Please find the enclosed Addendum No. 1 for the above referenced project.

ADDENDUM NO. 1
To the Contract Provisions for
City of Ferndale, Washington

**SECOND AVENUE (SCHEDULE A) Federal Aid Number: STPE-0445(003); and
MALLOY AVENUE (SCHEDULE B) Federal Aid Number: STPE-8029(002)
SIDEWALK PROJECTS**

SECOND AND MALLOY SIDEWALK PROJECTS
MALLOY AVENUE (SCHEDULE B)
SIDEWALK PLAN AND PROFILE

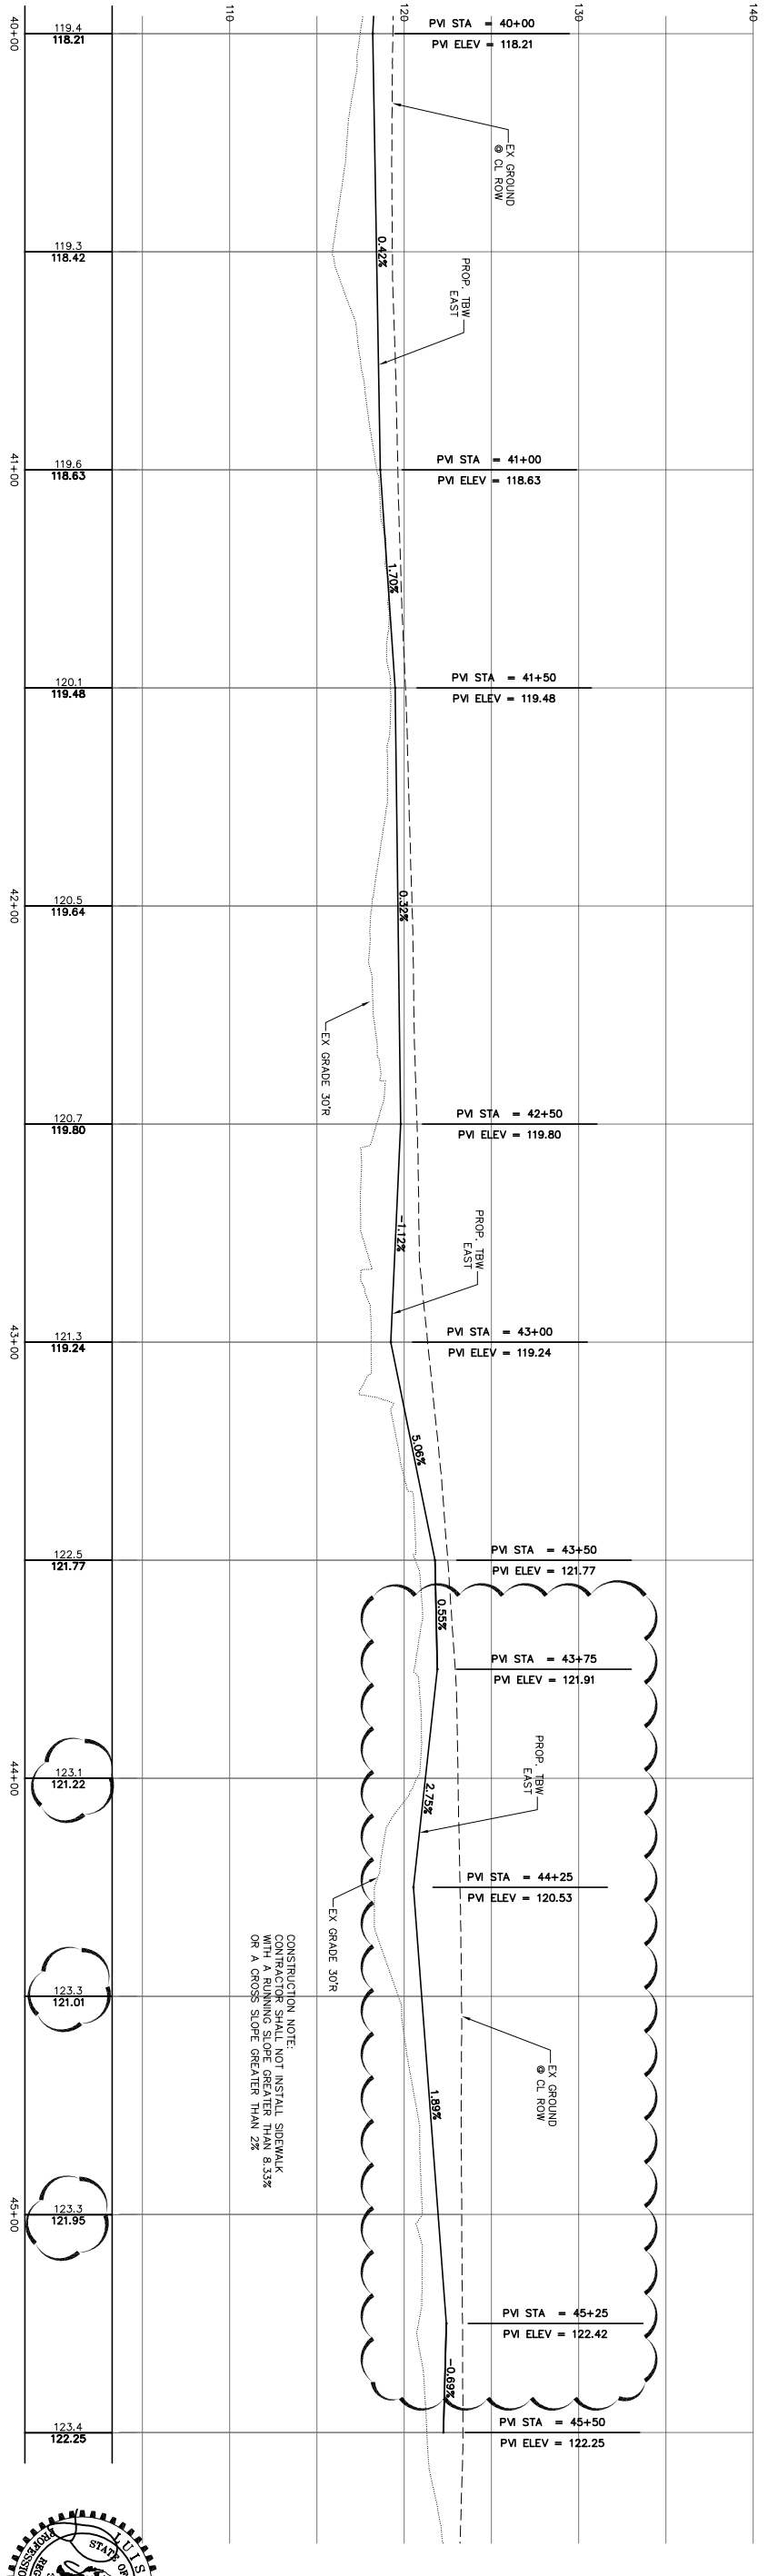
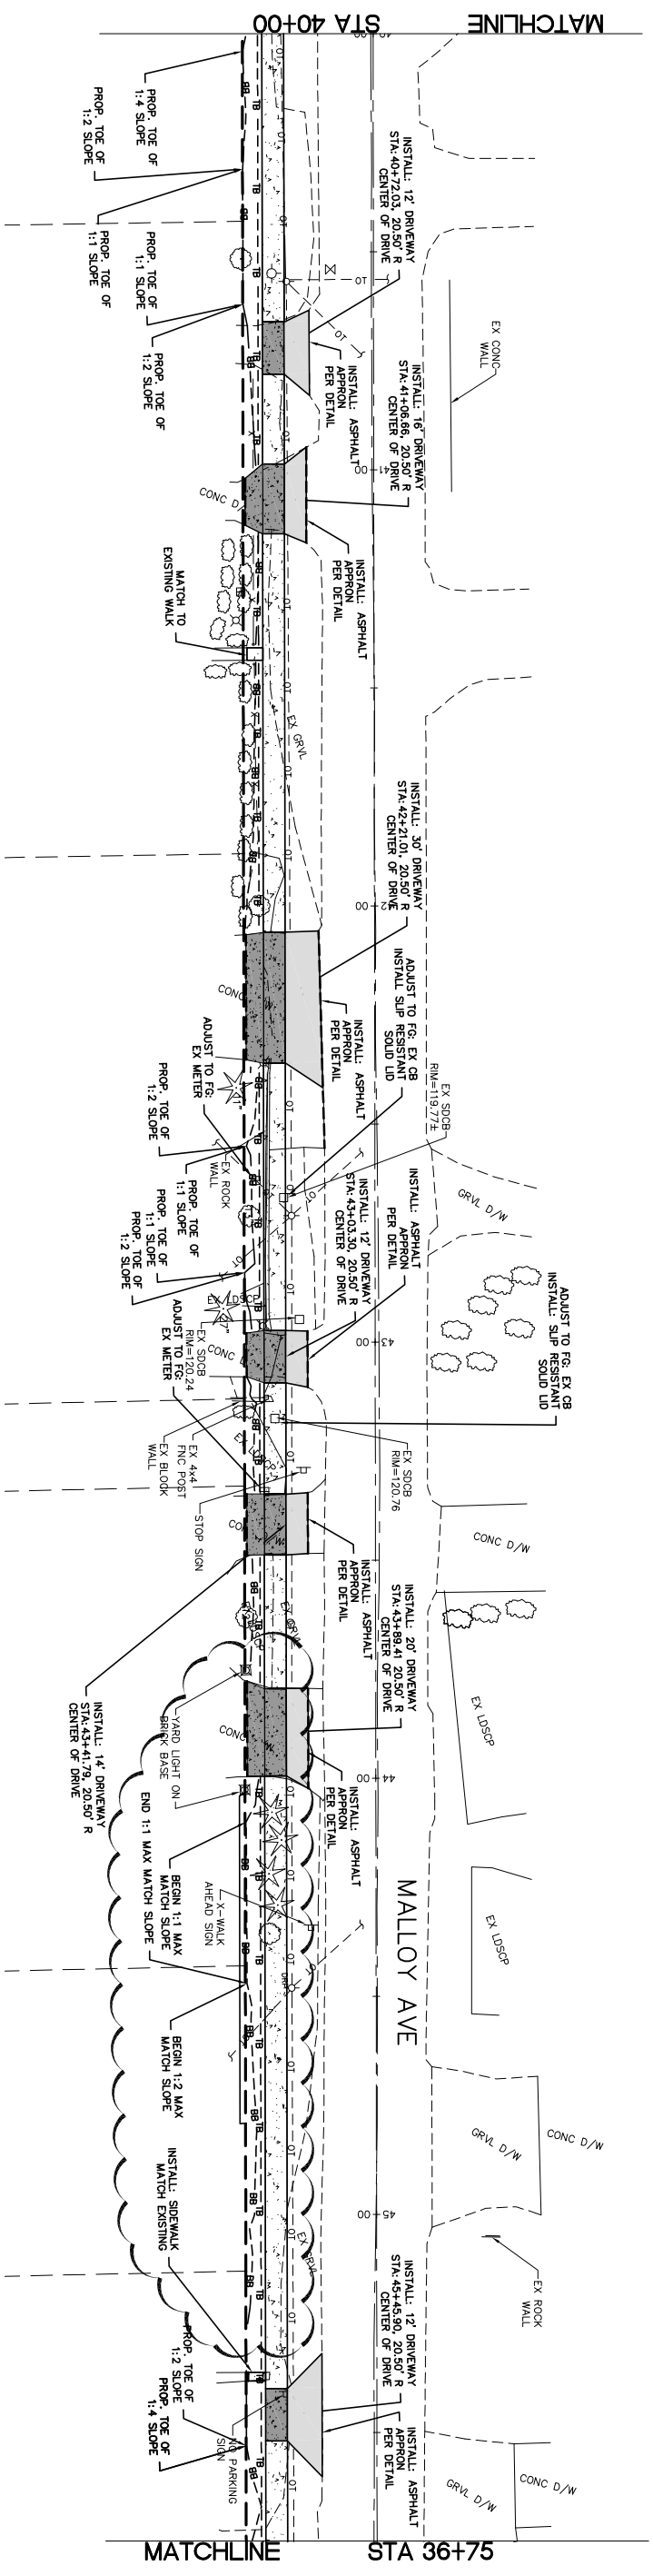
The attached Plan Sheets 16 shall replace the Plan Sheets 16 dated 8-23-11. Grades were revised.
